Re: Preliminary Plat for Lavitt Manor II—Two Lot Subdivision: 7525 N. Ironwood Drive

Based solely on the current Town of Paradise Valley Code and Storm Drainage Design Manual, the revised documents provided to this Commission by the Applicant for the proposed Lavitt Manor II subdivision have deficiencies requiring the Preliminary Plat be rejected:

PAVING GRADING DRAINAGE LAVITT MANOR II

5. PUBLIC HEARINGS 19-302 CONSIDERATION OF PRELIMINARY PLAT

PAVING GRADING PLAN
LAVITT MANOR II

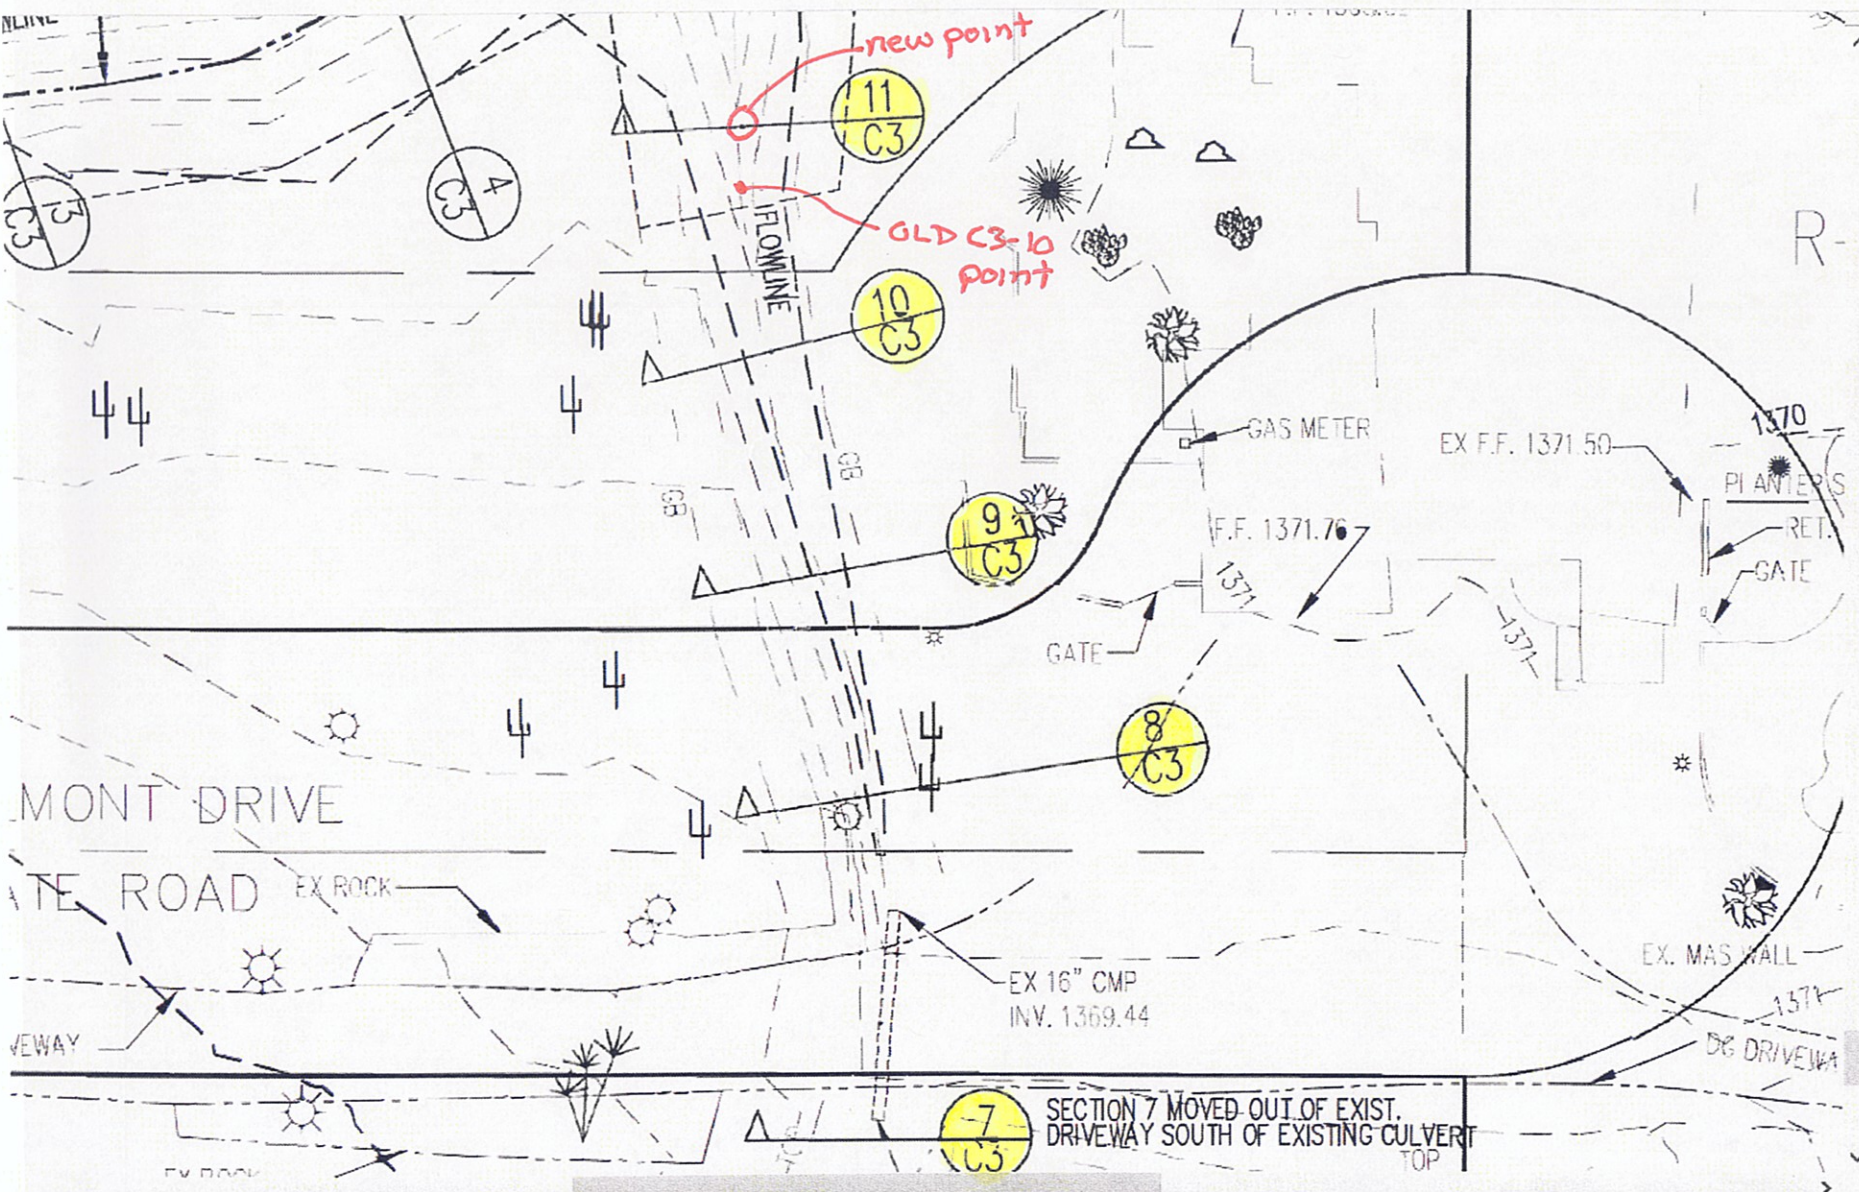
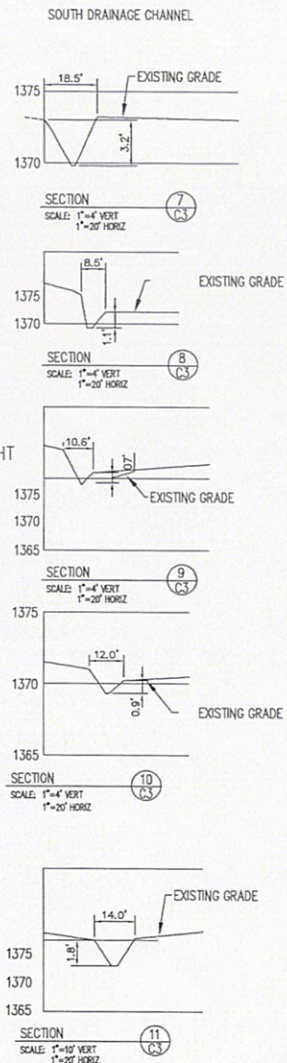
With this understanding, the revised plat points provided by the Applicant on page C3 of 4 of the Preliminary Plat for the Southern Drainage Channel, demonstrate the southern wash meets the definition of a "watercourse" and "Natural Wash" (Exhibits 2-8). The Applicant only took measurements from the shallow side of the wash to reach his conclusion the wash does not require an easement be provided to the Town of Paradise Valley. But as we all know, a wash has two banks—not one. The Code and *Storm Drainage Design Manual* requires measurements from the "top of the bank, which as discussed above, means both banks. When the measurements are reviewed for both sides of the southern wash, it meets the definition of a watercourse and Natural Wash. Applicants must dedicate this wash to the Town.

5 OF 5 > 2' VERT HEIGHT
5 OF 5 > 12" LENGTH
D.E. REQUIRED 1

4 OF 5 < 2' VERT HEIGHT
NO EASEMENT REQUIRED

9
C.3

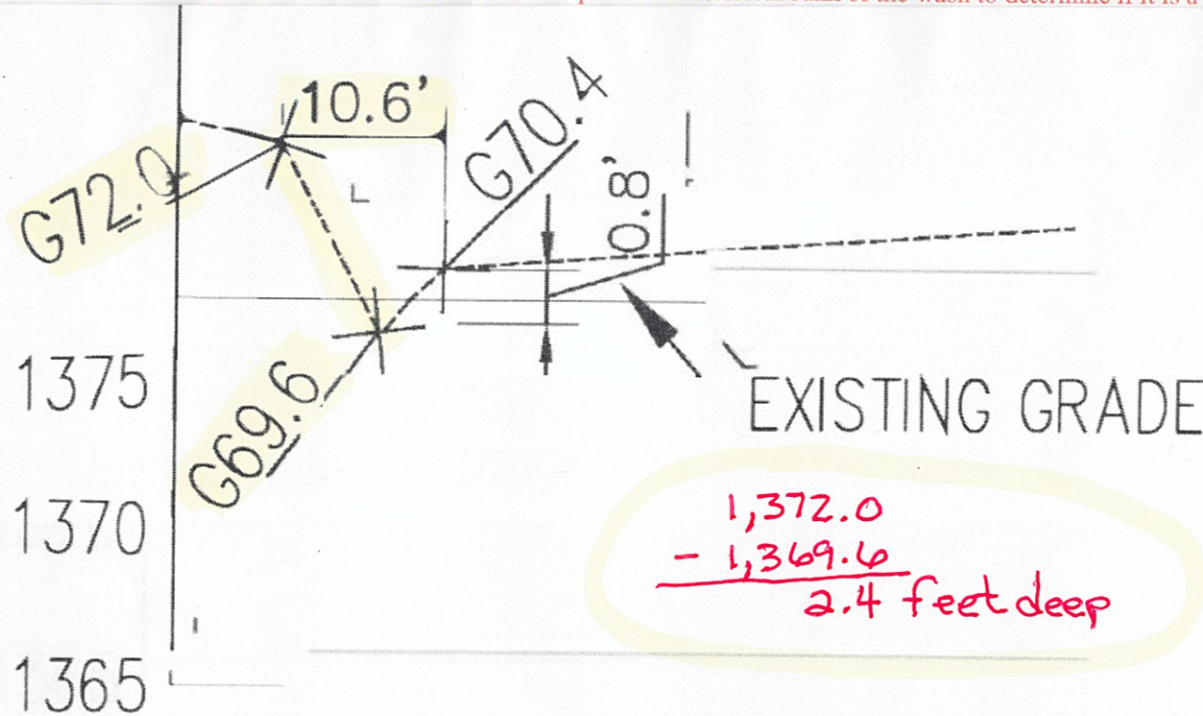
$$\begin{array}{r} 1373.0 \\ - 1369.7 \\ \hline 3.3 \text{ feet deep} \end{array}$$

- Must consider both "historical banks" to determine depth;
- Nowhere does it say watercourse depth is taken from one bank, lowest bank, or existing grade of one bank.

- Width must be determined by taking a measurement at the "top of the bank";
 - Can only mean at the top of each bank, or one could not obtain a width measurement from one bank.
- Accordingly, to ensure the same "top of the bank" meaning throughout the provisions, "top of the bank" must mean top of each bank;
 - Depth measurements must be taken from the top of each historical bank of the wash.

- Width must be determined by taking a measurement "to the top of the bank";
 - Can only mean to the top of each bank, or one could not obtain a width measurement from one bank.
- Accordingly, to ensure the same "top of the bank" meaning throughout the provisions, "top of the bank" must mean top of each bank;
 - Depth measurements must be taken from the top of each historical bank of the wash to determine if it is a Natural Wash.

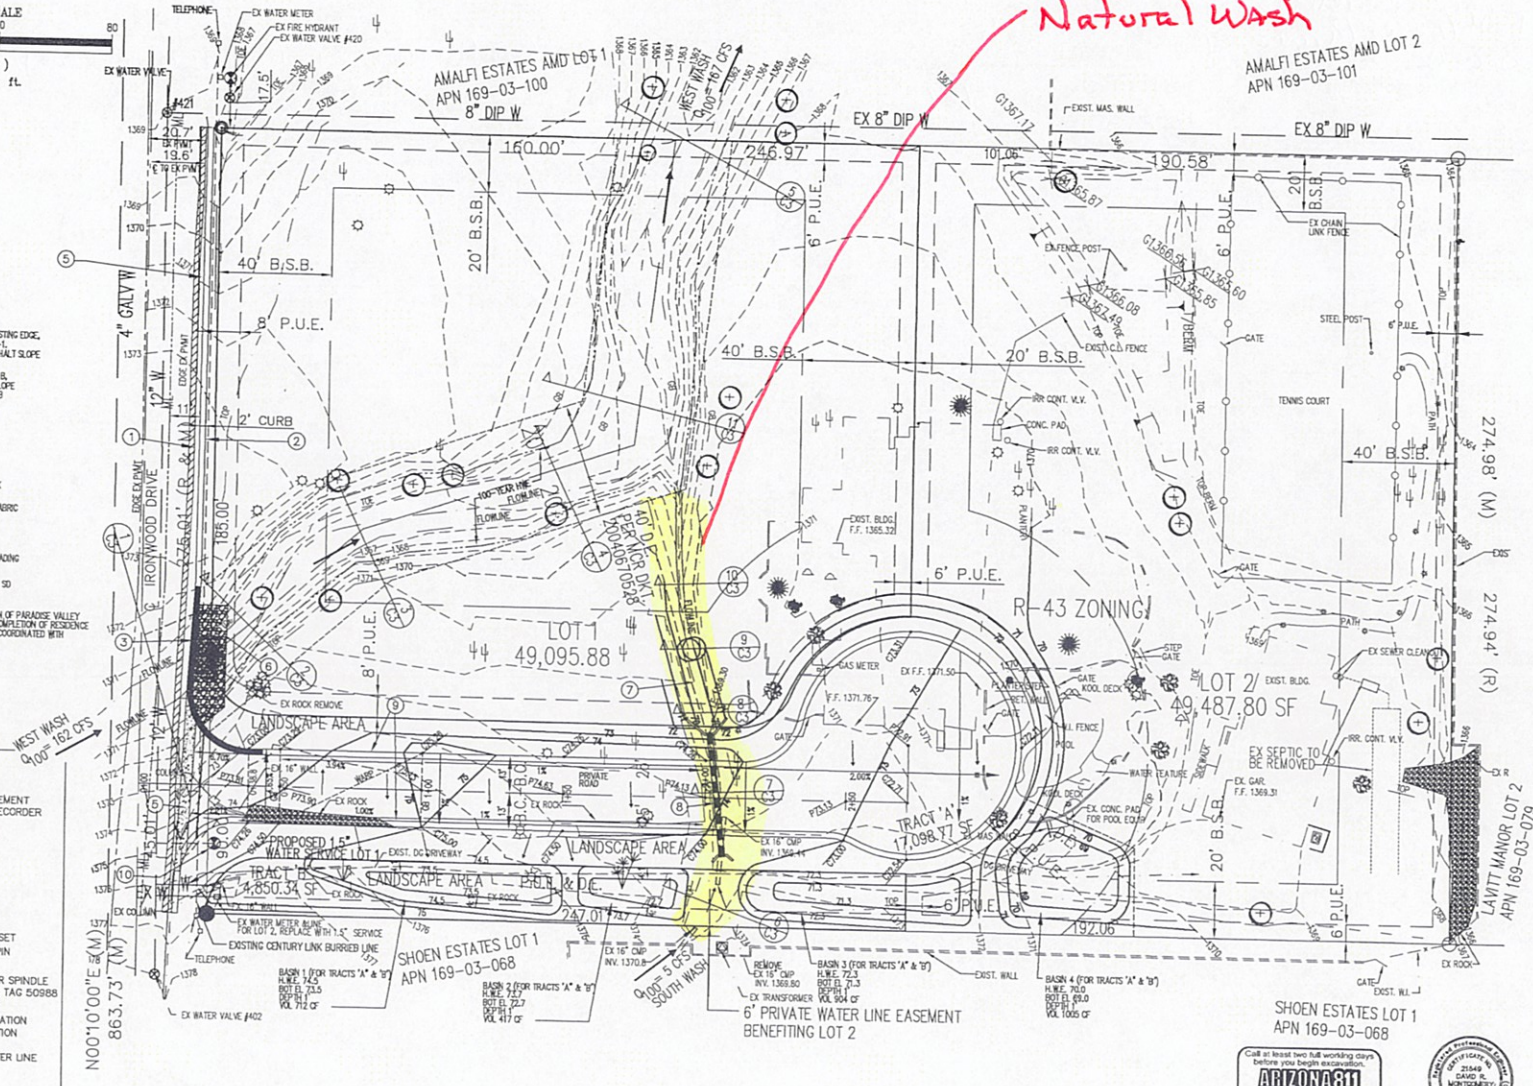
Does NOT show REQUIRED Landscape Buffer here or on plat 3-6(3) STORM DRAINAGE Design Manual

Suspected
Natural Wash

PAVING GRADING DRAINAGE LAVITT MANOR II

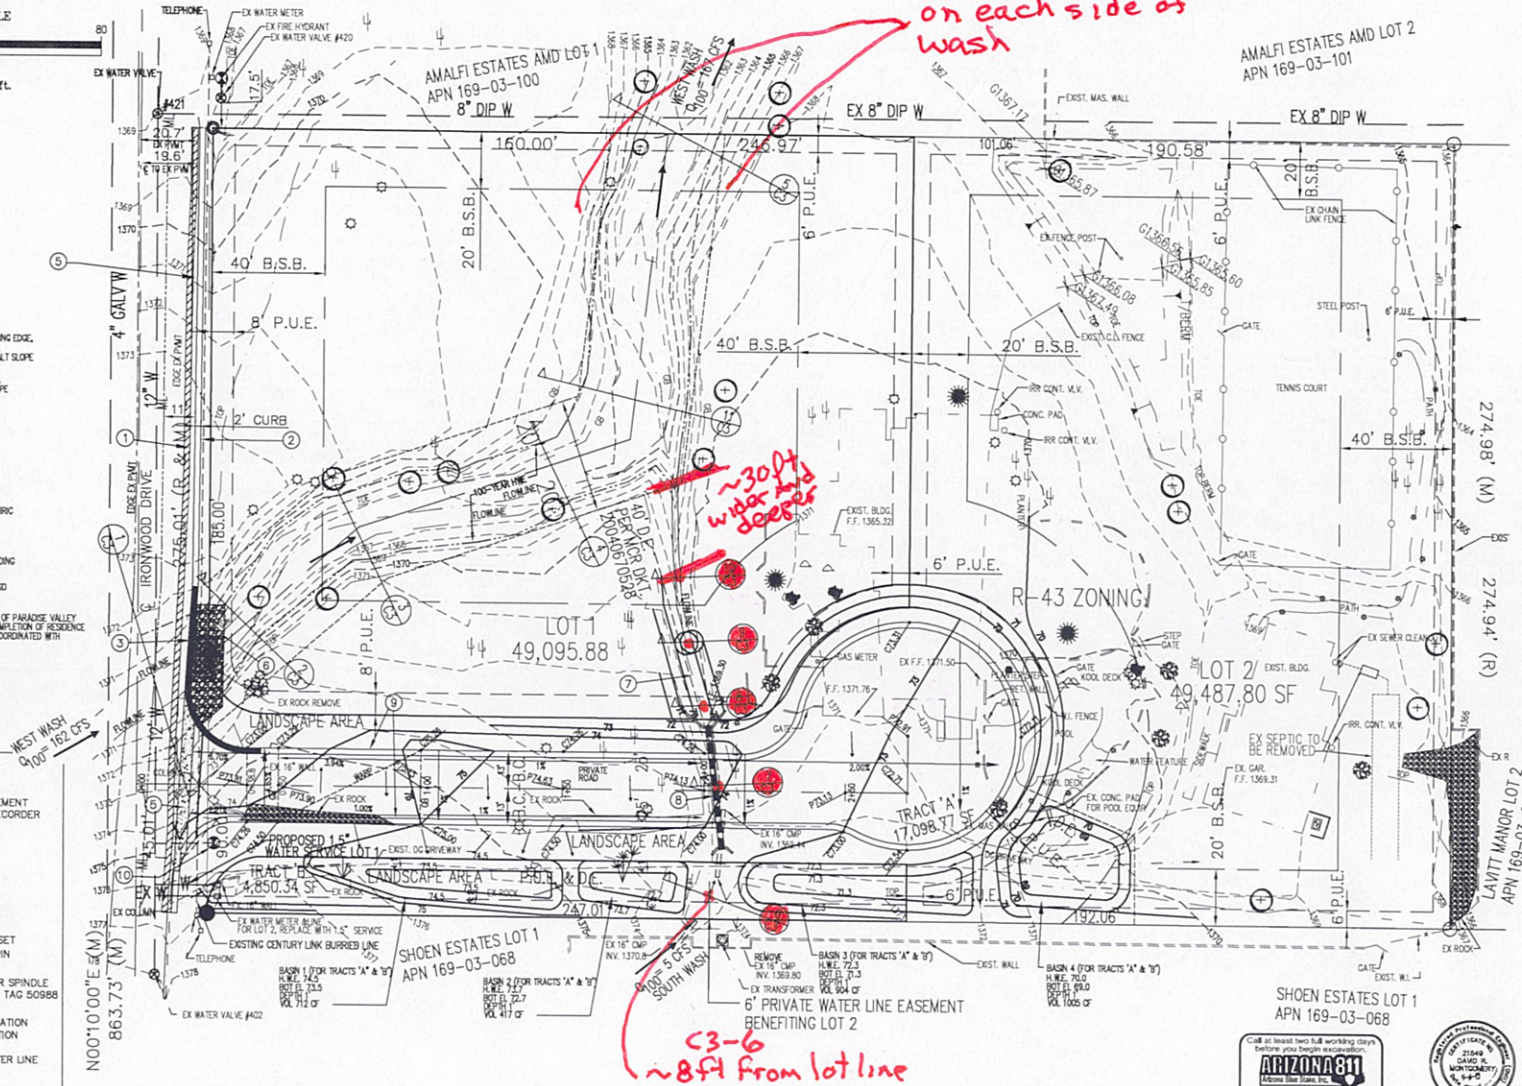
Did NOT provide LANDSCAPE BUFFER OR
EQUALLY SPACED CROSS SECTION ACROSS ENTIRE WASH

no buffer of 5'
on each side of
wash

~30ft
wider and
deeper

C3-6
~8ft from lot line

PAVING GRADING DRAINAGE LAVITT MANOR II

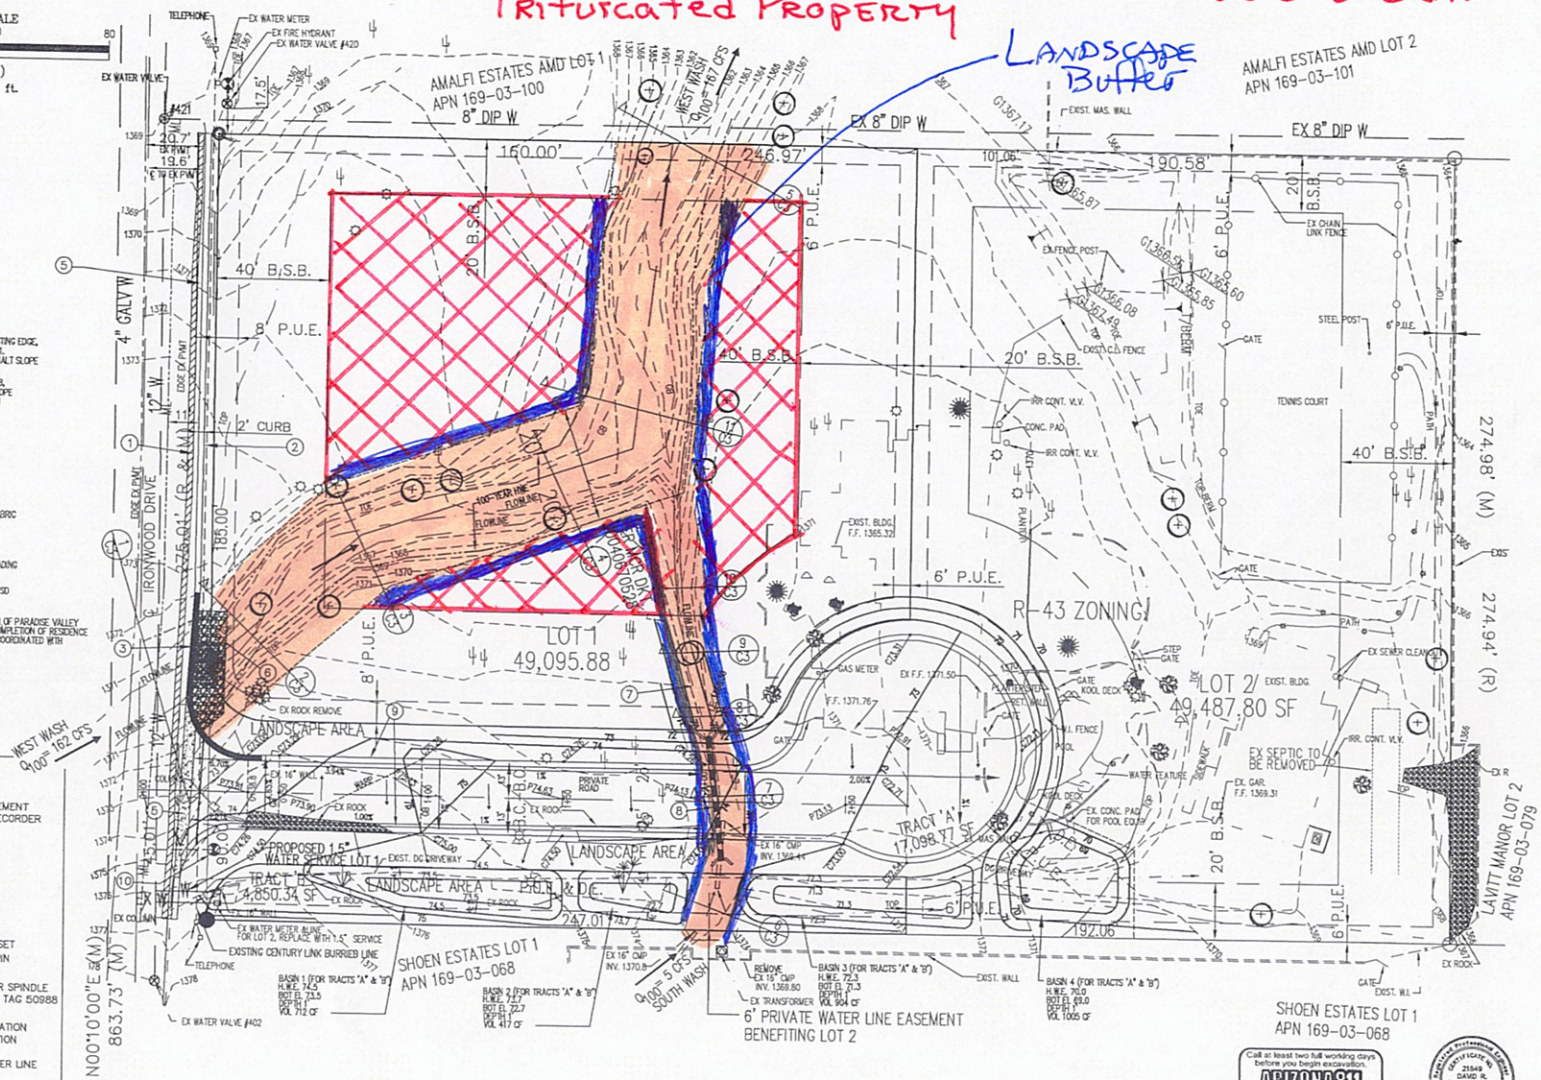
Trifurcated Property

No Satisfactory AND Desirable
Building side
PV Town Code 6-3-5(A)

LANDSCAPE
Buffer

**WASH EXHIBIT
LAVITT MANOR II**

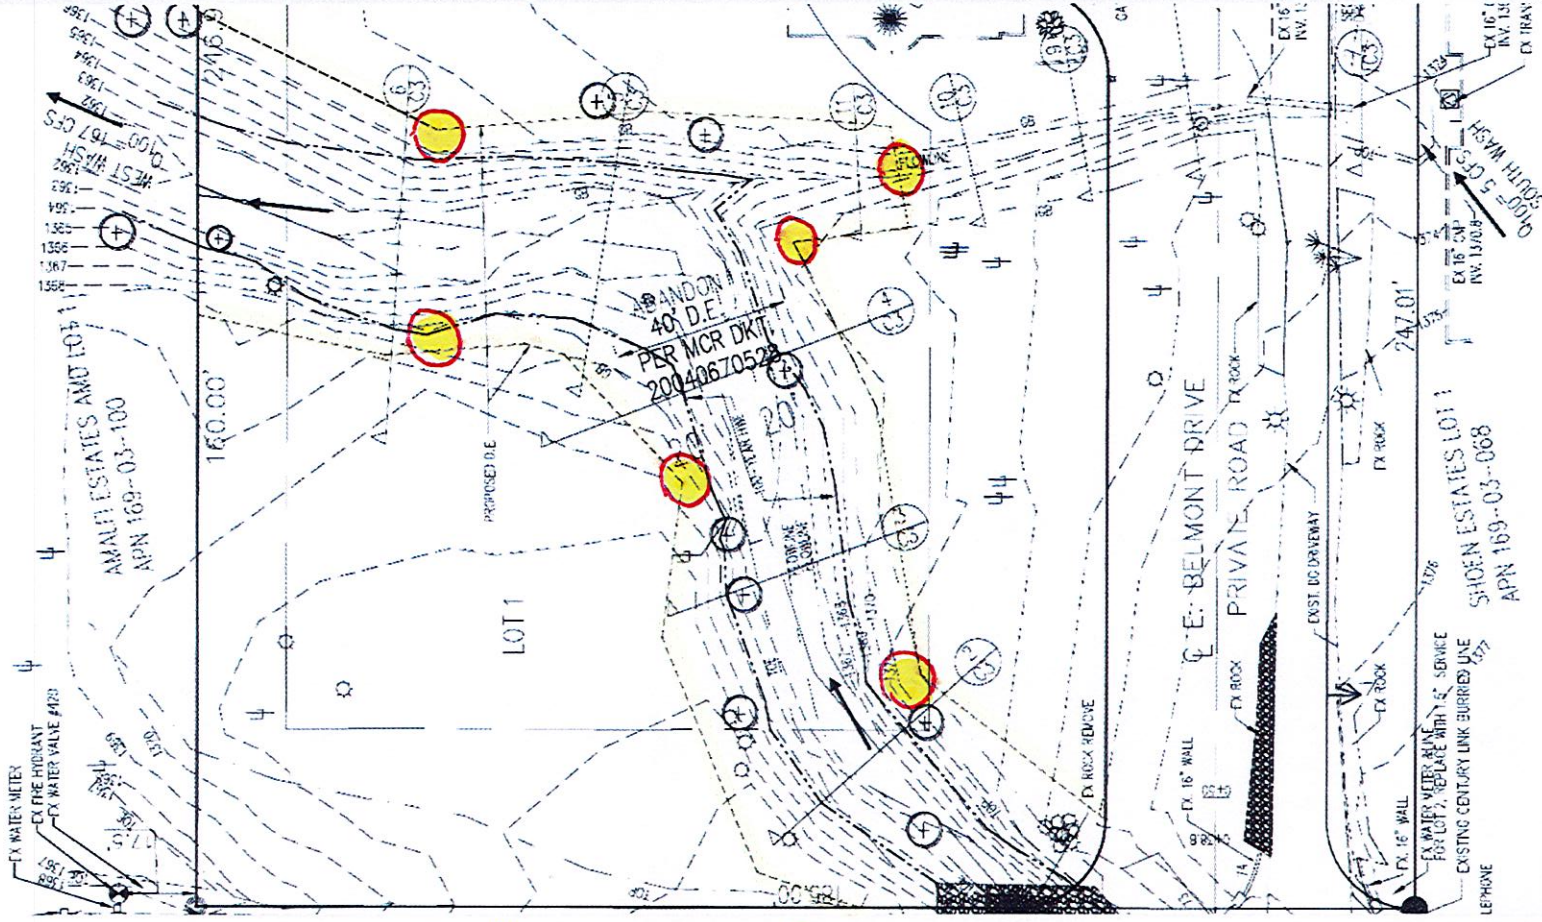
- Town of Paradise Valley is obtaining easement on Lot 1;
- Mandatory language (“shall”) to have a 5 foot landscape buffer on each side of wash;
- Current easement points approaches or encroaches Natural Wash at 3 points thus the landscape buffer is not appropriate;
- Plan should not be approved as it violates the Town Code.
